## Addendum to ID3000 Manuals

Panel software version 4.33 introduces the following enhancements:

**Section 4.4.3 changes**

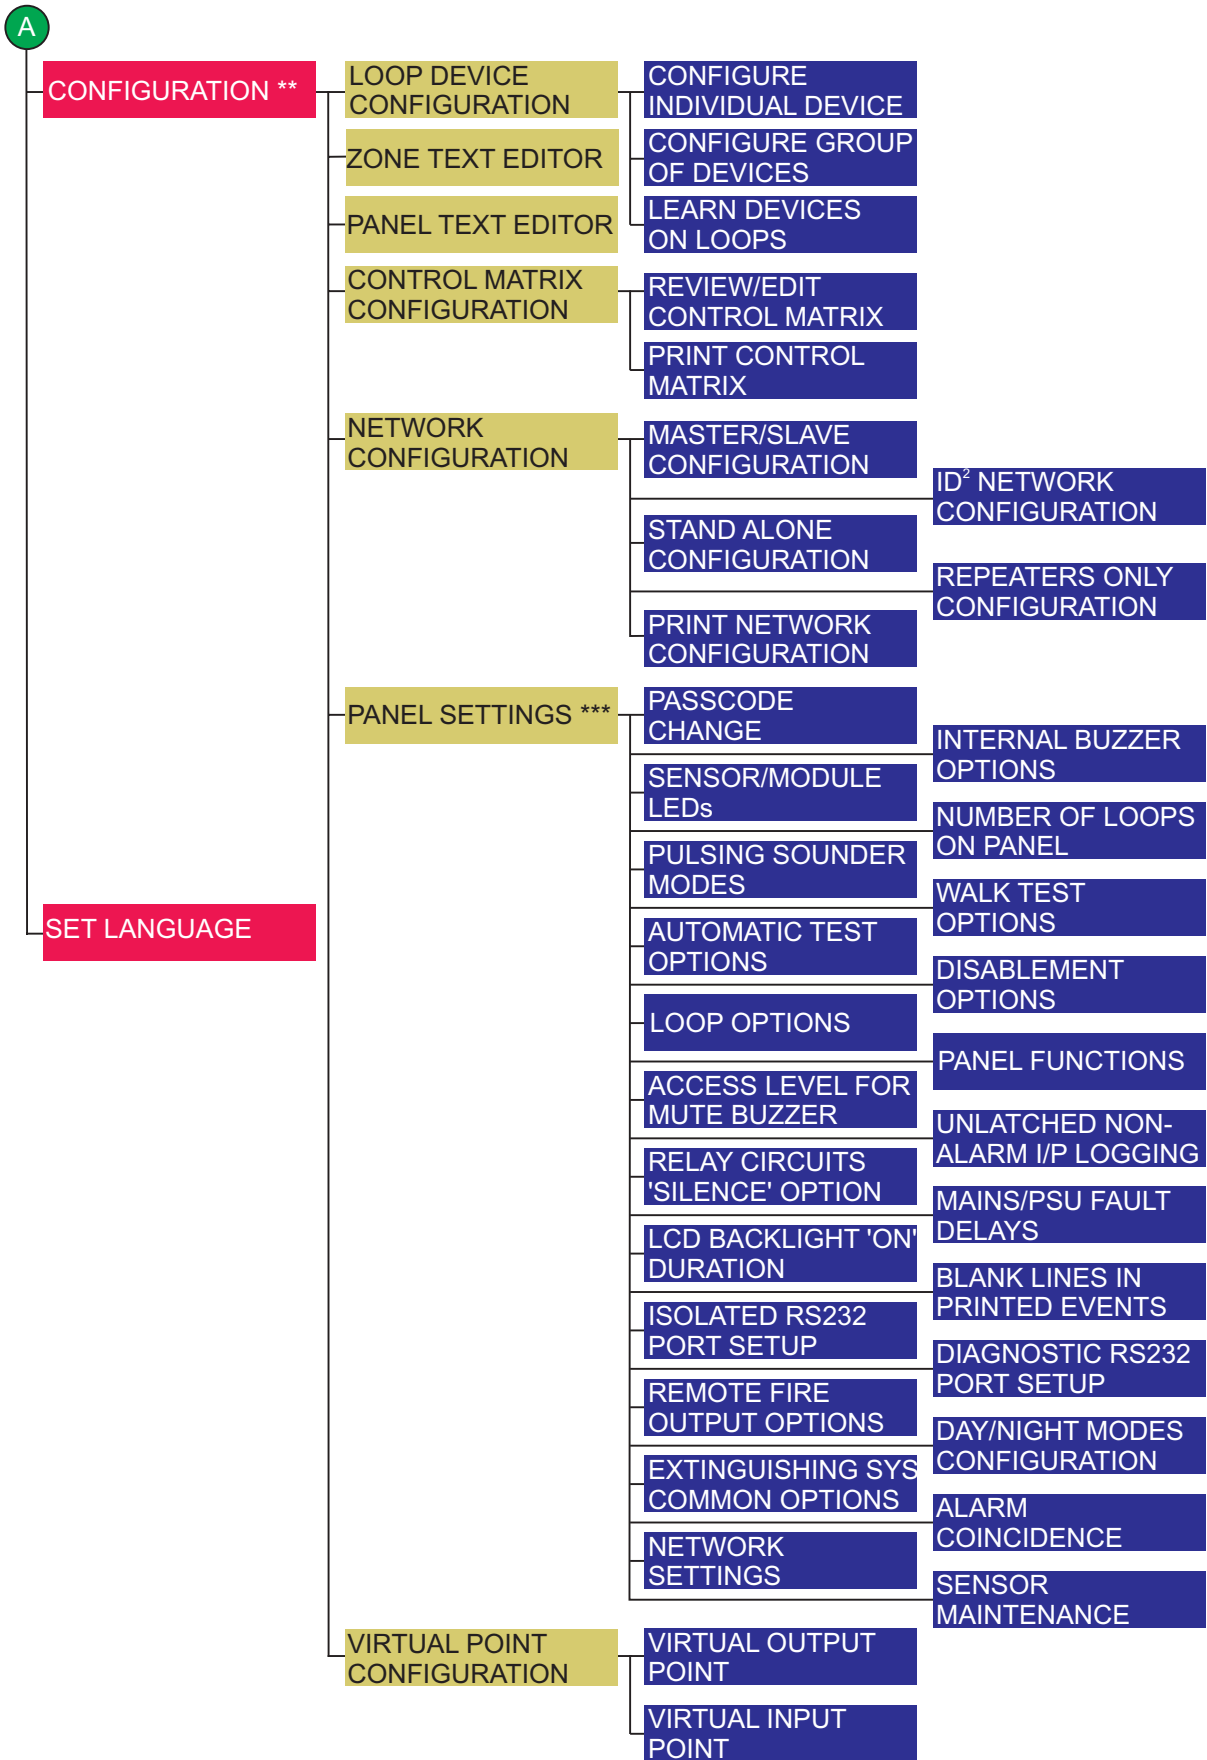
Updated menu structure, see next page.

Section 7.2 changes

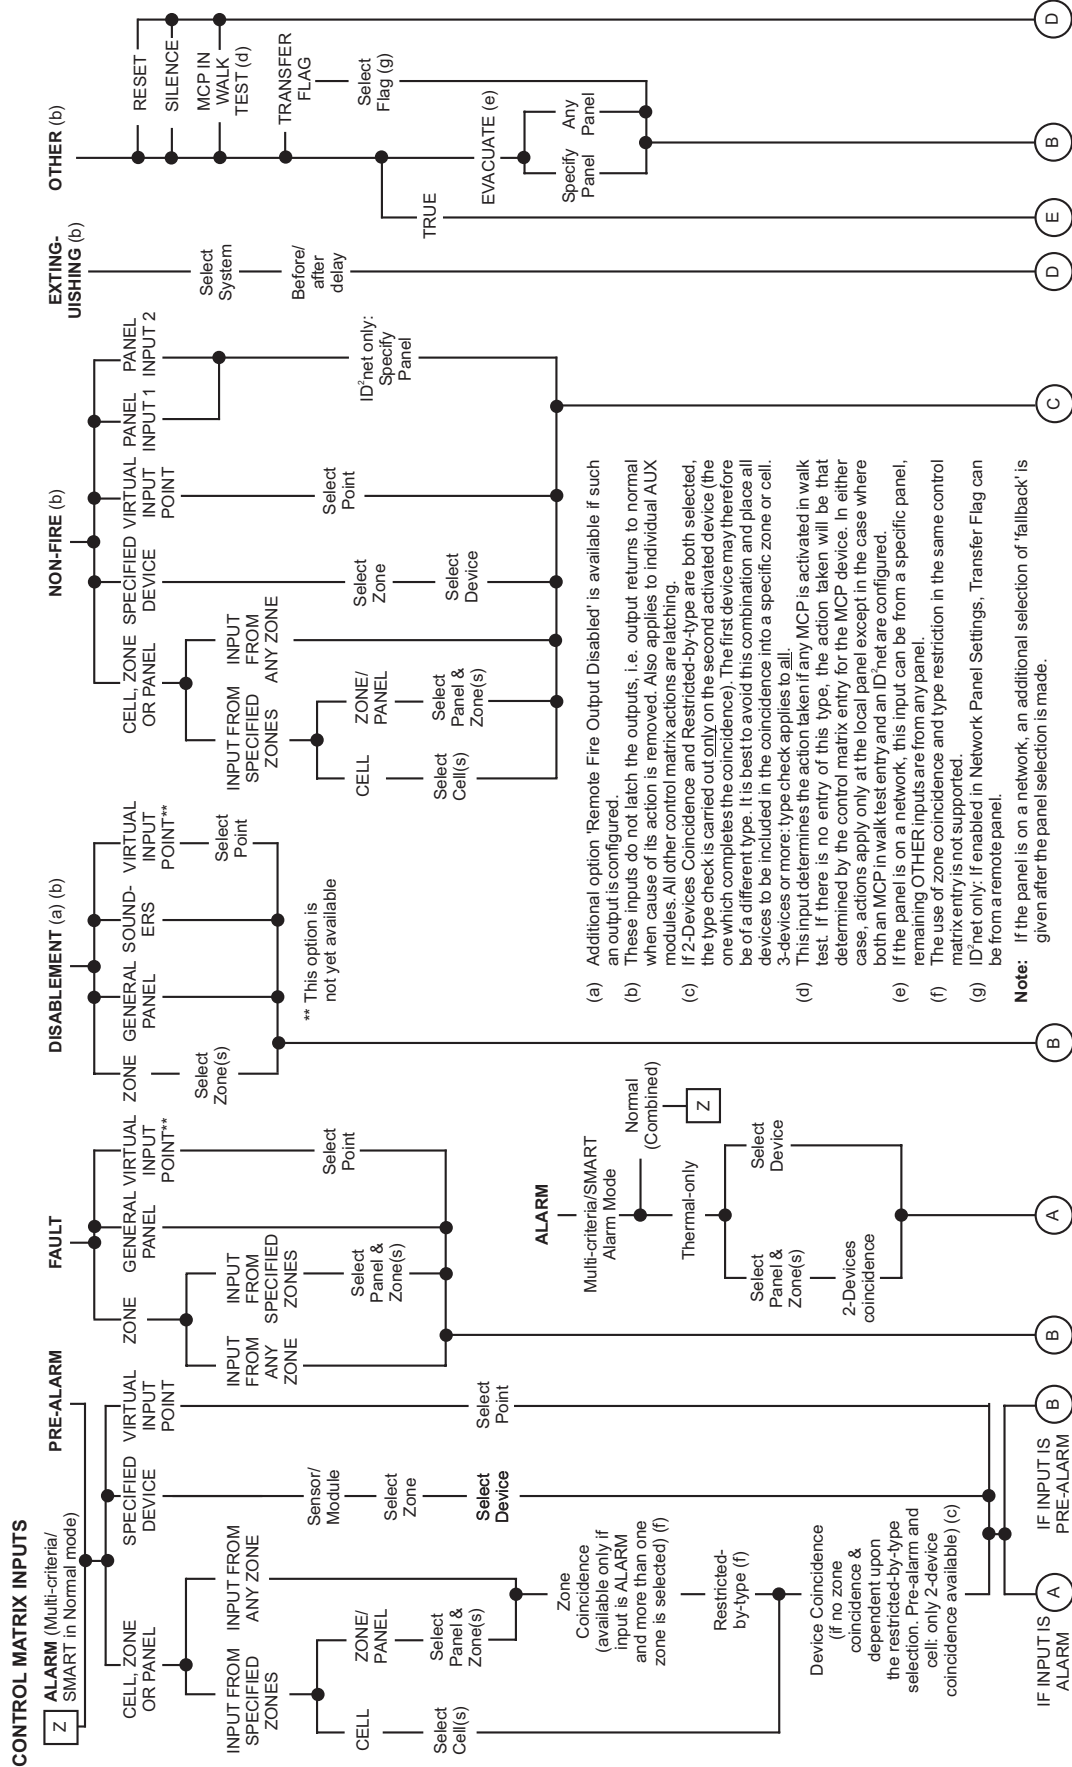
The illustration now shows the Thermal Alarm option to the Control Matrix input.

Section 7.3 changes

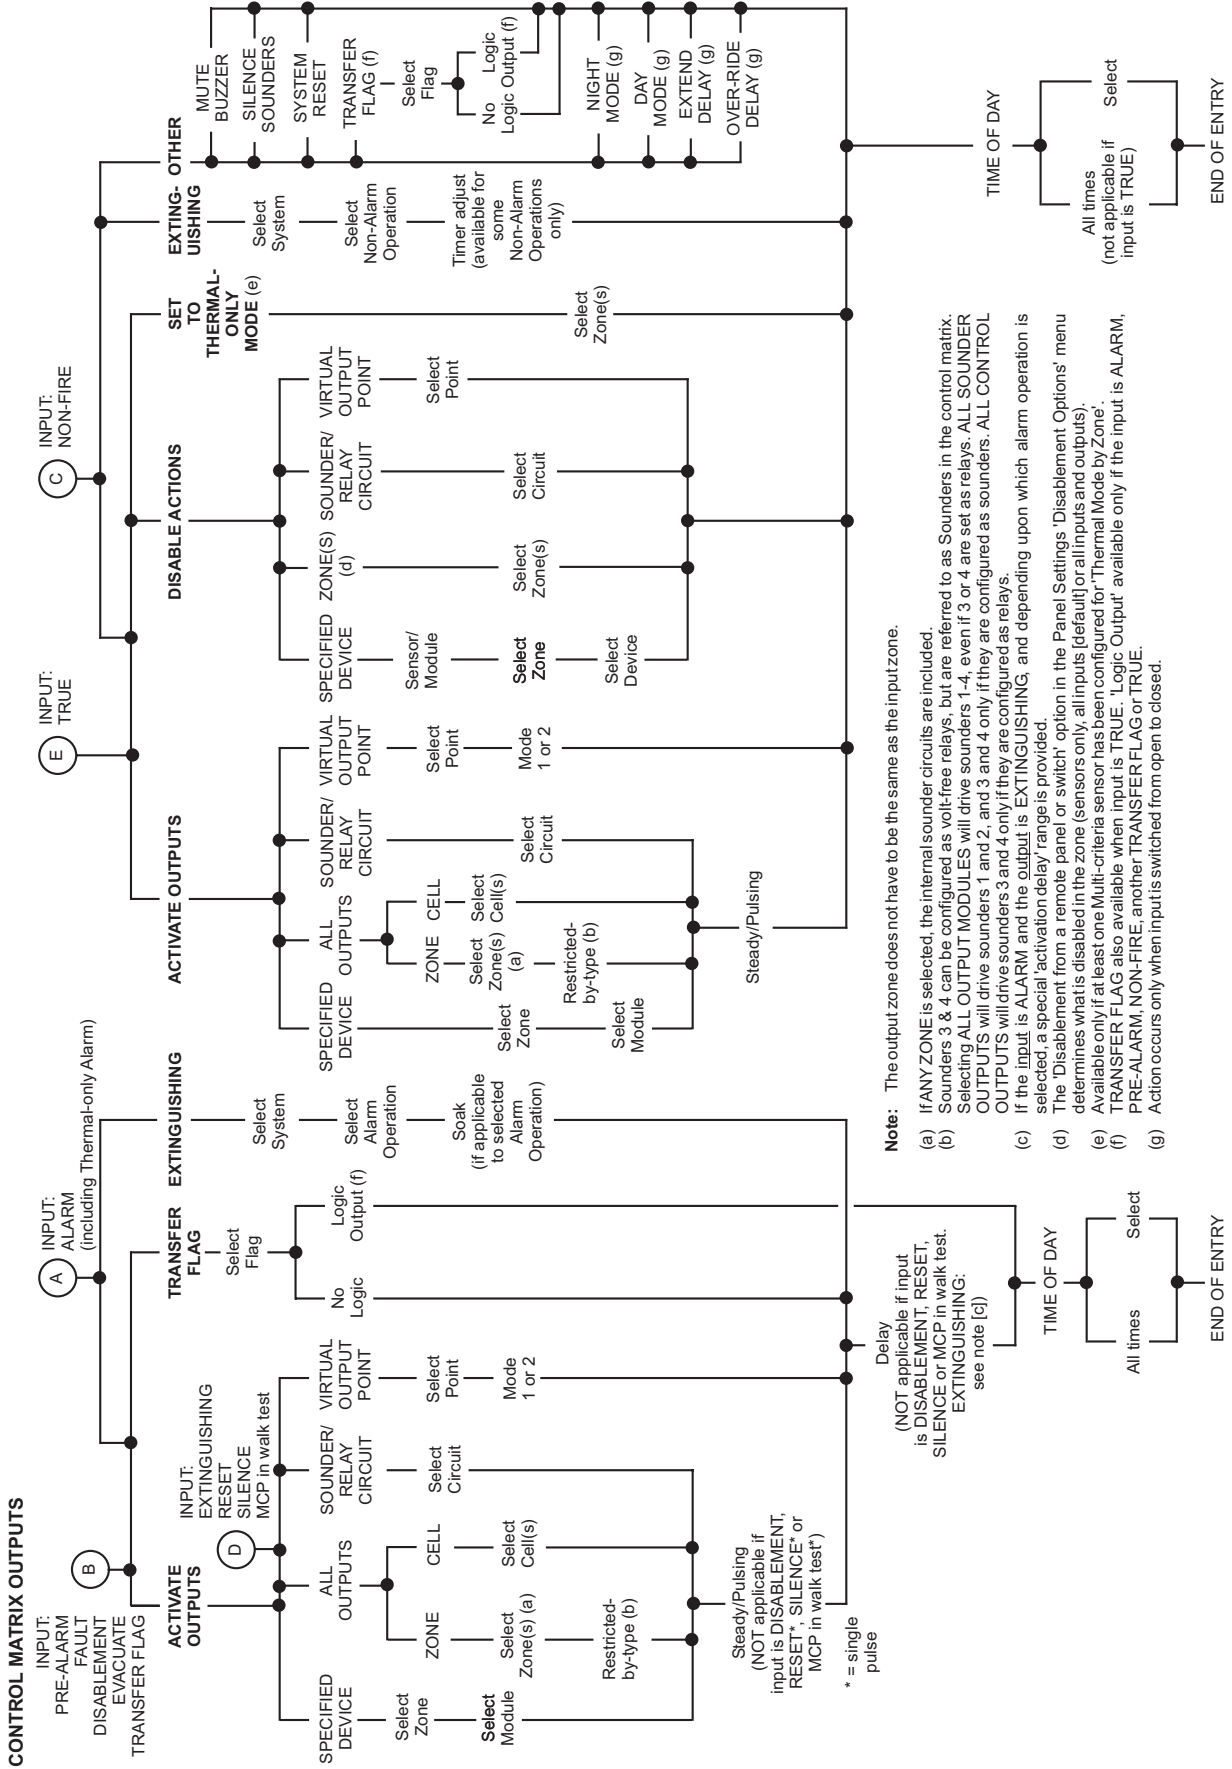
The illustration now includes Thermal Alarm as a possible input option 'A'.
